STAFF RECOMMENDATION
1402 Douglas Avenue
June 21, 2017

Application: New construction—addition
District: Eastwood Neighborhood Conservation Zoning Overlay
Council District: 06
Map and Parcel Number: 072140196
Applicant: Greg Griffin
Project Lead: Jenny Warren, jenny.warren@nashville.gov

Description of Project: Application is to construct a rear dormer where the side walls are not inset from the main walls of the house.

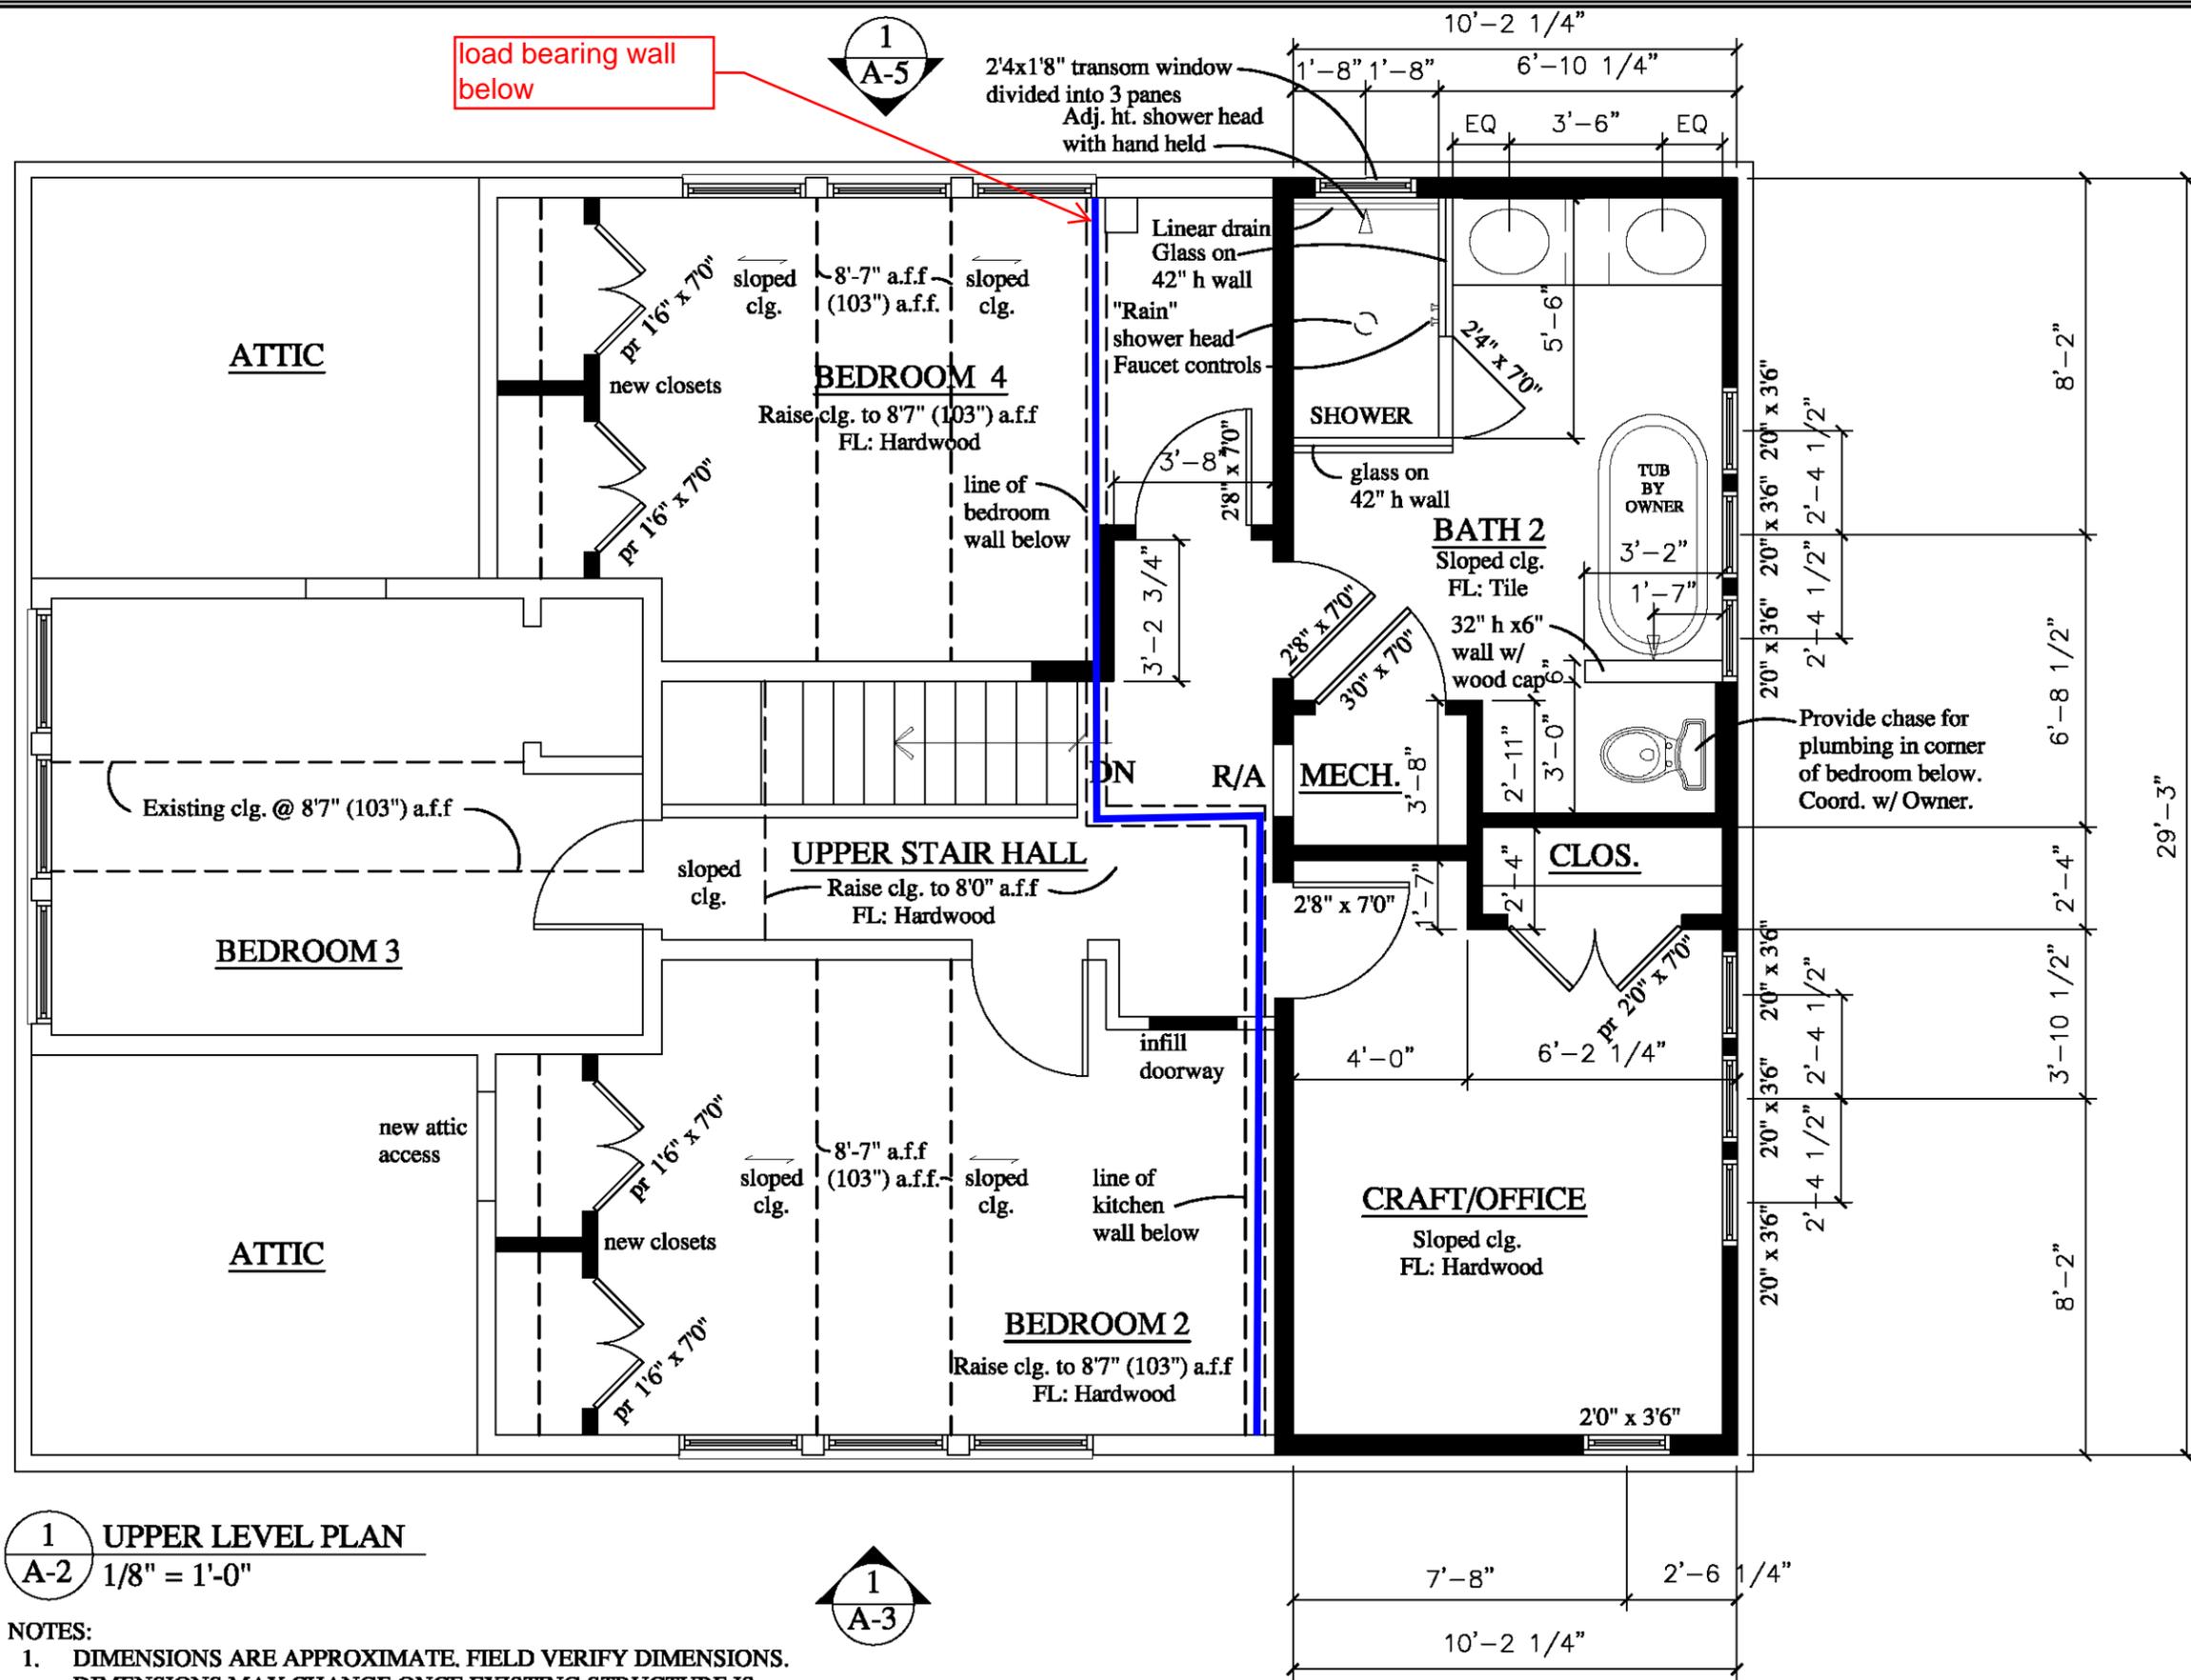
In terms of location, the proposed design stacks the side walls of the dormer flush with the main walls of the house. The guidelines state that rear dormers should be inset from the side walls of the building by a minimum of two feet (2') on either side. The Commission has not previously approved rear dormer additions with walls stacked over the historic walls. The requirement for inset dormer walls is intended to keep the massing of rooftop additions modest and to prevent them from overshadowing the scale of traditional historic homes.

Staff finds that the addition does not meet Section II.B.2.a of the design guidelines for location due to the width of the dormer, relative to the width of the house.

Design: The proposed design of the addition is largely compatible with the historic house. The addition's materials, typical shed roof form, subordinate height, scale, and fenestration pattern are all compatible with the historic character of the existing house. Staff's one concern with the design is that the side walls of the dormer are not inset two feet (2') on either side, as required by the guidelines.

Proportion and Rhythm of Openings: With one exception, the windows on the proposed addition are all approximately twice as tall as they are wide, thereby meeting the historic proportions of openings. One smaller bathroom window is located on the east side of the dormer. Staff feels that in this location, the smaller, horizontally oriented window is appropriate. There are no large expanses of wall space without a window or door opening. Staff finds the addition’s proportion and rhythm of openings to meet Sections II.B.1.g. and II.B.2. of the design guidelines.

Recommendation Summary: Staff recommends approval with the condition that the dormer is set in two-feet (2’) from each side. With this condition, Staff finds that the project meets Section II.B.2. of the design guidelines for the Eastwood Neighborhood Conservation Zoning Overlay.

1 REAR ELEVATION
 A-4 1/8" = 1'-0"

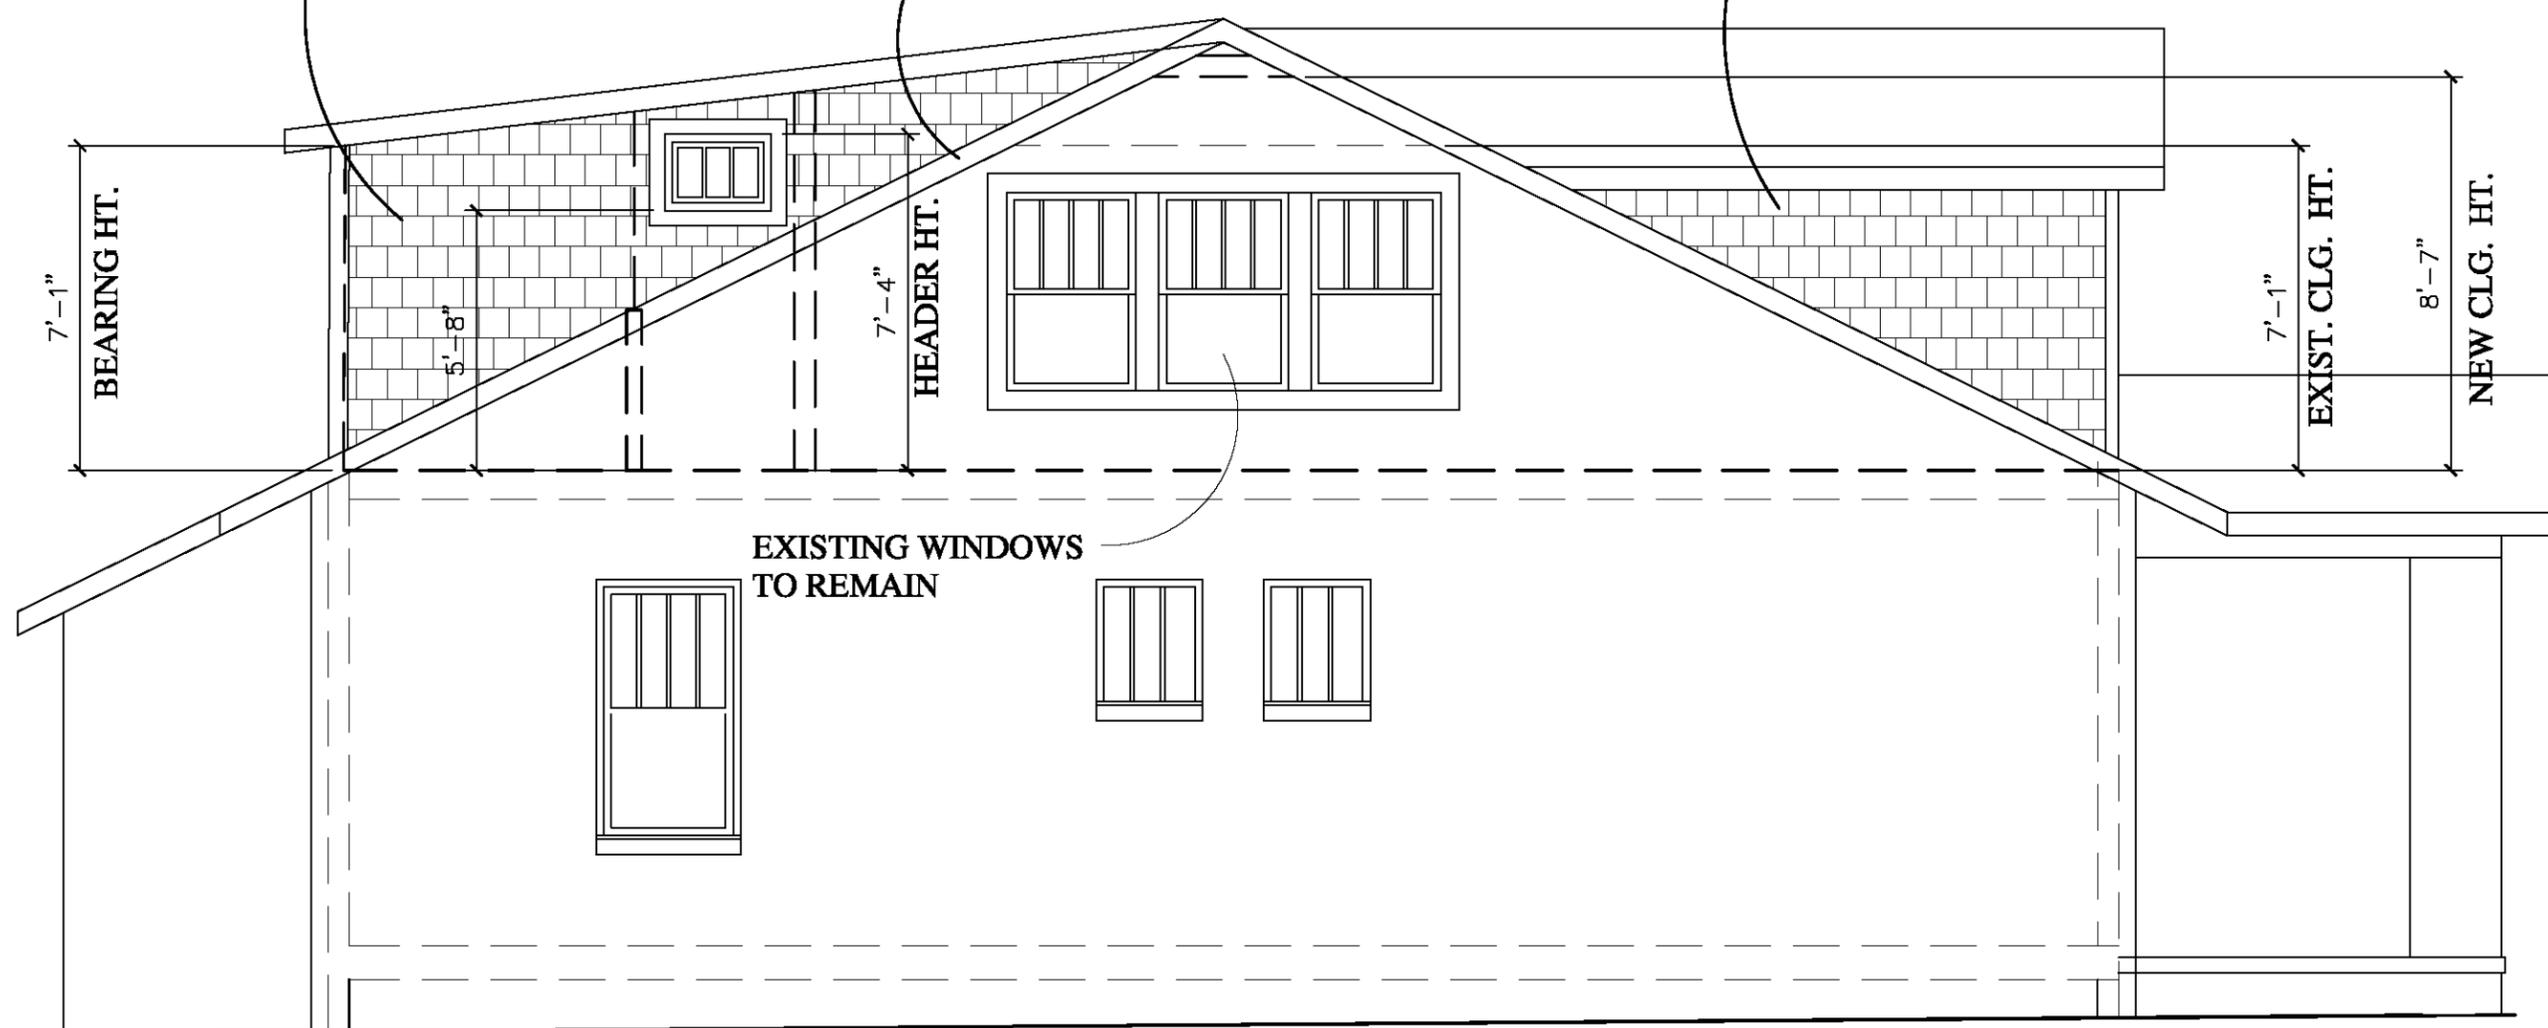
Roof form: The proposed roof form will be a shed roof added onto the existing side gabled roof, at the rear of the house. The pitch will be approximately 1.5/12, which Staff finds to be appropriate in this low-visibility location. Staff finds that the addition’s roof form meets Sections II.B.1.e. and II.B.2. of the design guidelines.

1 SECTION
 A-6 1/8" = 1'-0"

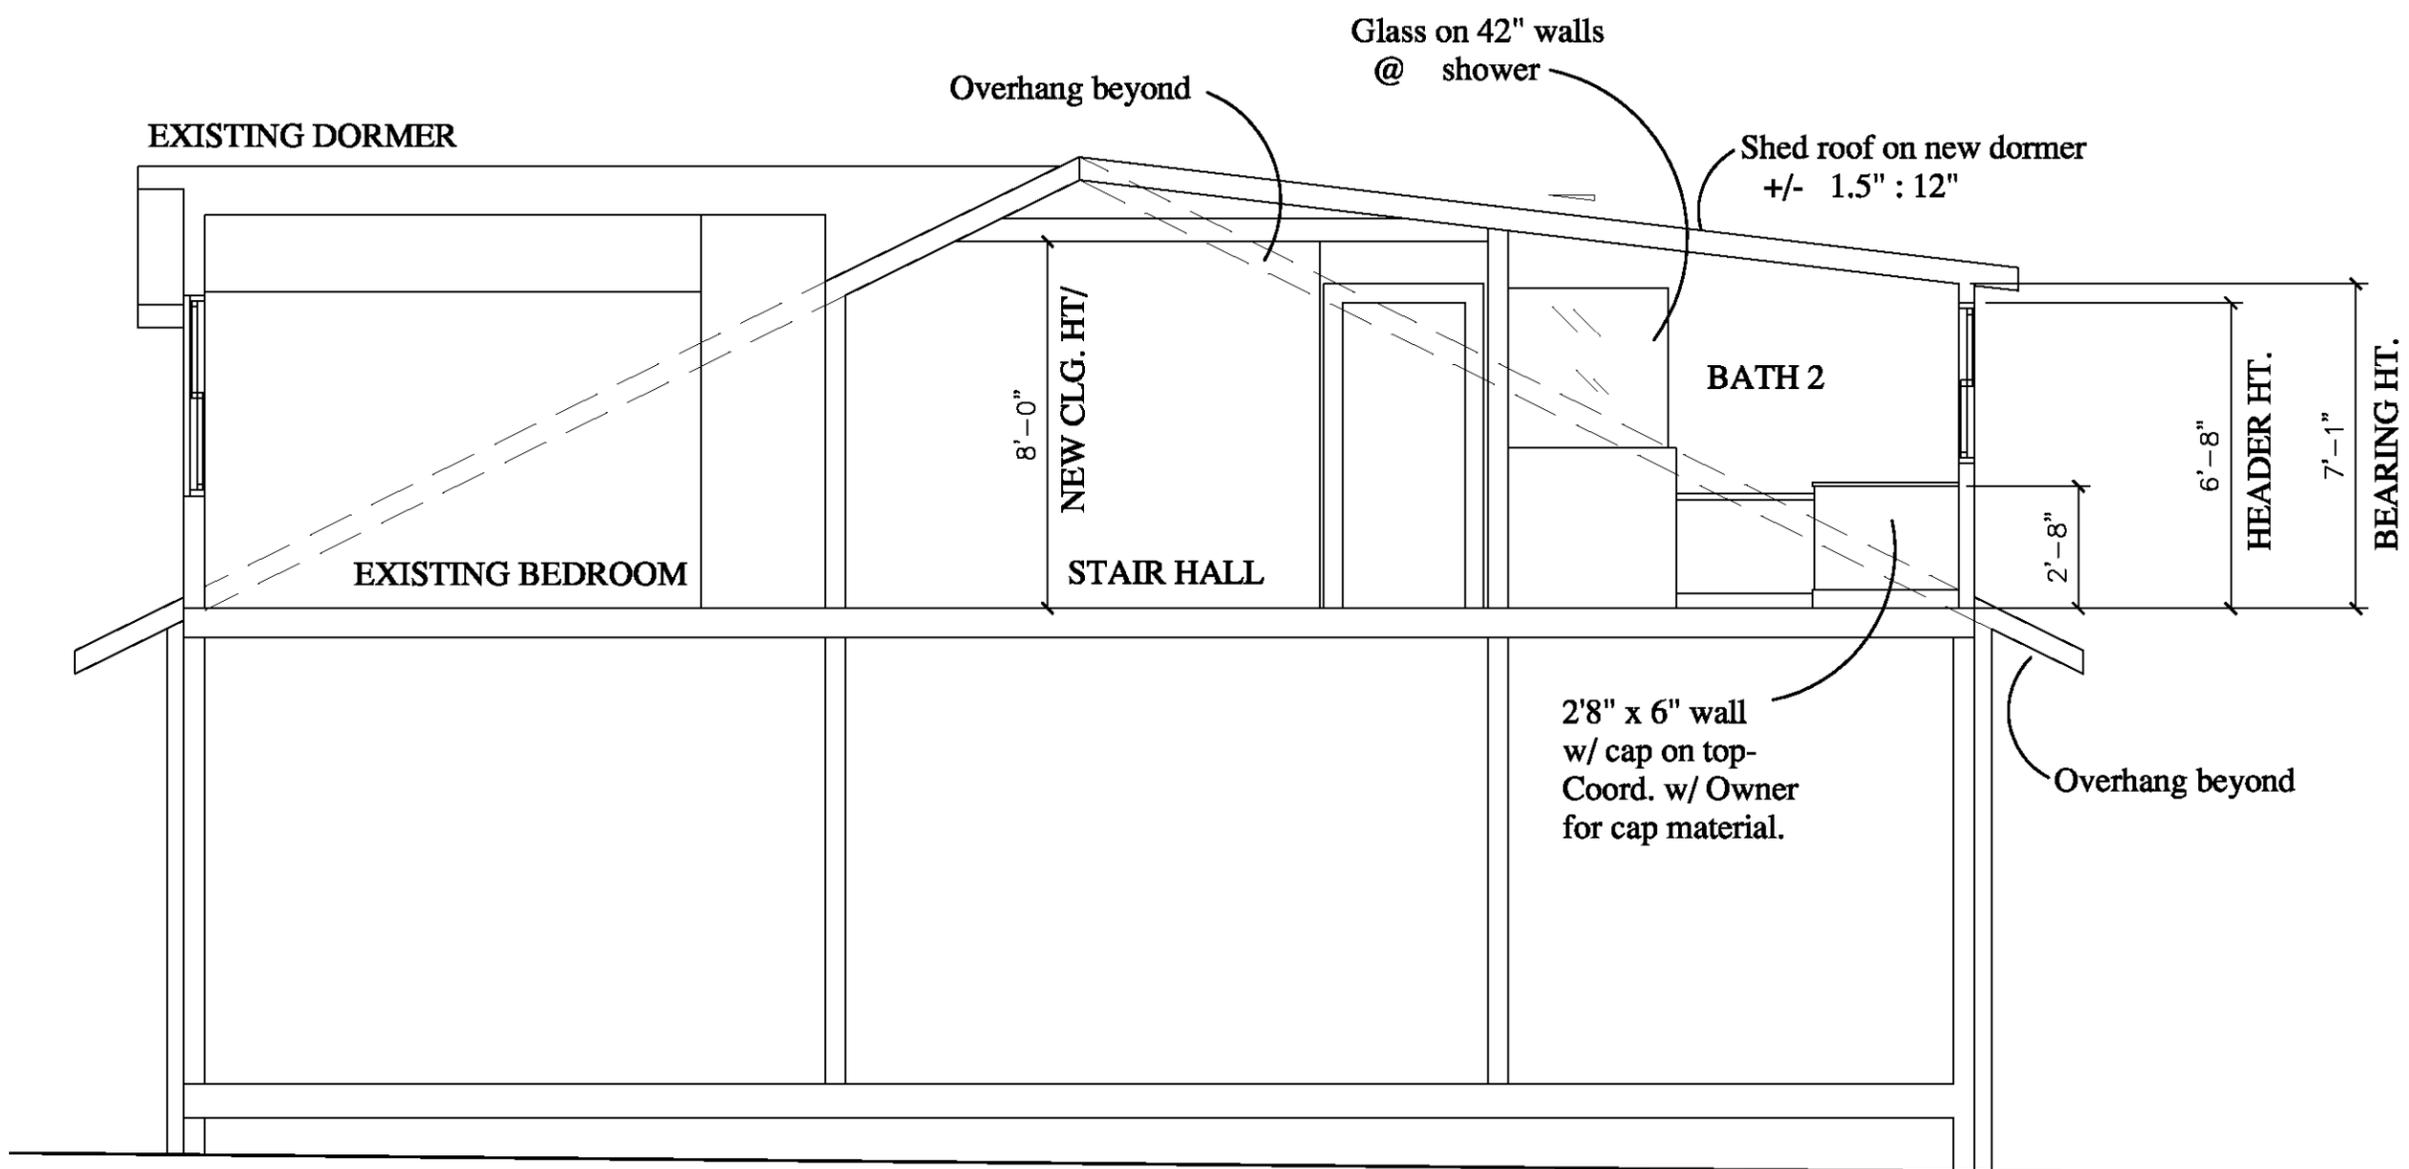
Partial Demolition: The proposed rear addition is a shed dormer off the back of the house. The dormer will tie in at the ridge line and will terminate above the original rear exterior wall. The addition requires no change in footprint. Rear dormer additions are commonly approved and Staff finds that the partial demolition of the roof is appropriate.

Height & Scale: The proposed addition will add square footage to the second story of the home. It will not extend higher than the existing historic ridge height, thus will not increase the overall height of the historic property.
